## MEMORANDUM

**RE:** Response to Taylor Run Stream Restoration – Field Geology Services Report  
WSSI #28006.01

**DATE:** April 16, 2021

Figure 1. Channel evolution model.

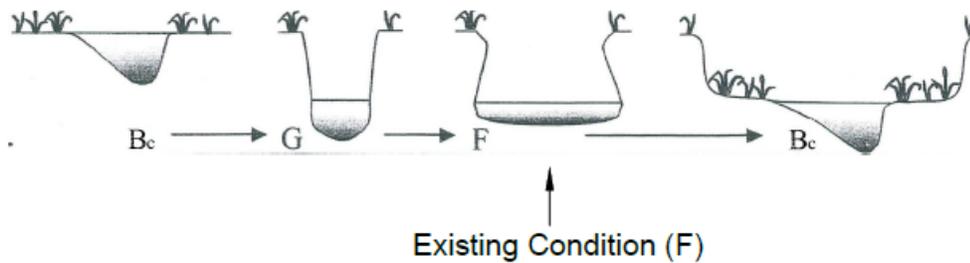
The author points to the presence of hard pan, erosion resistant clays at the base of existing vertical banks as an indicator that the system has reached equilibrium. The following image was taken from Sheet 74 of the design plan set. This image illustrates the evolutionary process as a channel changes to adapt to altered watershed conditions. Consistent with this model, the design team sees erosion resistant parent materials in the lower portion of the channel as an indicator of lesser potential for downcutting and a transition to the widening process as the channel increases cross-sectional area to reduce stresses. This assessment is confirmed by numerous locations where rock/concrete rubble has been dumped along the stream banks to arrest this ongoing widening process. Design team conclusions are further supported by portions of the Field report, including the fact that “once widening has progressed sufficiently over a period of several decades, the stream achieves a new equilibrium, when the incision and widening have reduced flow velocities to the point where only the smaller amount of sediment coming from the urbanized watershed can be transported despite the greater runoff.”

The proposed restoration design is consistent with the understanding of natural channel evolution, as depicted in Figure 1. If left unchecked, the system would continue to widen before establishing a new floodplain at a lower elevation – a fact acknowledged in the Field report. Allowing this process to progress naturally over the coming decades is impossible at the Taylor Run site due to constraints posed by existing road, trail, and sanitary infrastructure. Therefore, the proposed design uses fill material, an engineered erosion resistant reinforced bed, and strategic placement of rock structures to reestablish a channel invert elevation consistent with past conditions at the site prior to severe erosion. This approach reduces channel stresses and creates a narrow bankfull bench. The approach is consistent with the channel evolution model, as broadly understood by industry professionals and described in the Field report but requires intervention since the upstream supply of sediment has been cut off by watershed development.

Figure 2. Design profile showing existing drop of over 3-ft at culvert outlet.

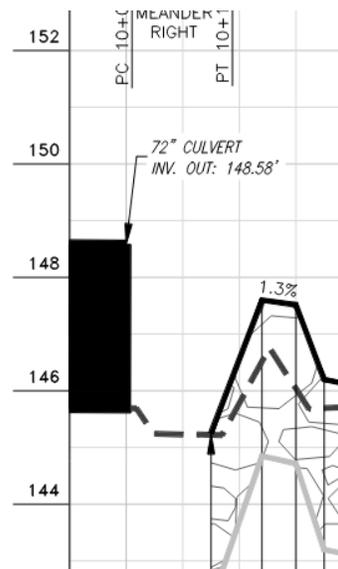
The Field report points to the upstream culvert as further confirmation that the system has reached equilibrium, noting that the upstream culvert “with its bottom essentially at the current bed level, demonstrates that no widespread incision has occurred since the culvert was installed decades ago.” However, the preceding sentence in the report indicates bed degradation throughout the reach, stating that hardpan clay “indicates that further deepening of the channel through incision is not possible”. On-site observation and survey information presented in design plans (Sheet 14) clearly show a channel invert more than three (3) feet of elevation difference between the culvert outlet elevation (148.58) and the existing channel bottom. The drop or downcutting would be greater were it not for the concrete rubble that has been dumped at the outfall to arrest further degradation. Areas downstream of the outfall show even greater bed erosion.
